ON SITE SEWAGE DISPOSAL SYSTEM DESIGN PLAN
PARCEL B
WINDSOR FOREST
PLAT No. 22269
18950 WINDSOR FOREST ROAD
FOURTH ELECTION DISTRICT
HOWARD COUNTY, MARYLAND
SCALE: 1"= 50' DECEMBER 2018

PROJECT: Windsor Forest, Parcel B

REMARKS: Review of Horse Barn septic connection. Thank you!

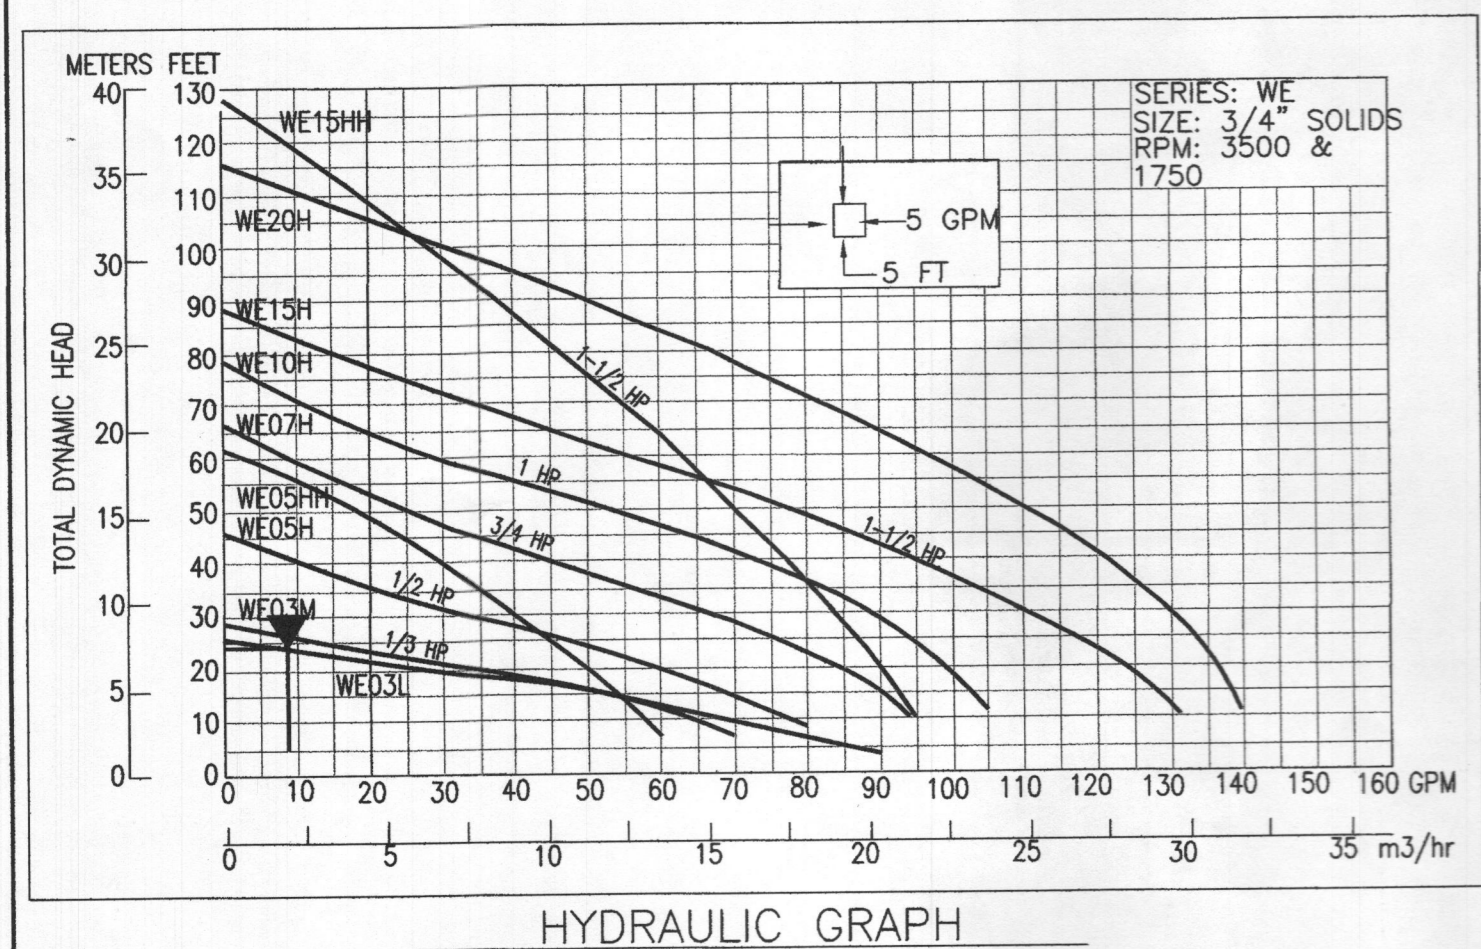
I looked up the records and do see that we allowed that on the other property. It is not ideal to do that, but if we allowed it there, we will allow it here. The plan will need to show the tank with no slot in the center wall. It will need to have a hole near the top of the center wall at least 4" diameter with a tee extending into the first chamber to 16" from the bottom and extending up near the lid above the liquid line with no cap. The tank will need an access manhole over the center wall for future replacement of that tee, so 3 manhole covers total. The pump will need to be a sewage pump with specs given to us showing that it's capable of passing 2" solids. The pump floats will need to be set with the pump off float higher than the 16" inlet on the tee on the other side.

Finally, this system is required to have an effluent filter meeting NSF standard 46 requirements to keep horse hair from washing blankets from getting to the drip field. If this tank setup is used, the effluent filter will need to be installed on the back end of the existing septic tank that this is pumping to. We will need to see a filter model specified on the plan with specs showing that it is NSF standard 46 listed.

I see that you are pumping the waste to the existing system, so we will need to see a separate, appropriately sized pump tank after the septic tank with the details of the pump, the dosing, the elevations, etc. This system will also need an effluent pump on the new septic tank, we'll need to see a specification for that, it needs to meet NSF requirements. Finally, the tie in to the existing system needs to be shown in detail. We will want to see the line empty into the gravity line leading into the tank instead of drilling a new hole into the tank itself. Thanks
Jeff

- HORSE BARN SEPTIC SYSTEM DESIGN:
- DESIGN FLOW EQUIVALENT TO ONE BEDROOM OR 150 GPD.
 - PROVIDE 1000 GAL. SEPTIC TANK AND 500 GAL. PUMP TANK.
 - PROVIDE WASHABLE NSF 46 CERTIFIED EFFLUENT FILTER AT SEPTIC TANK OUTLET. EFFLUENT FILTER SHALL BE TUF-TITE EF-4 EFFLUENT FILTER OR EQUIVALENT.
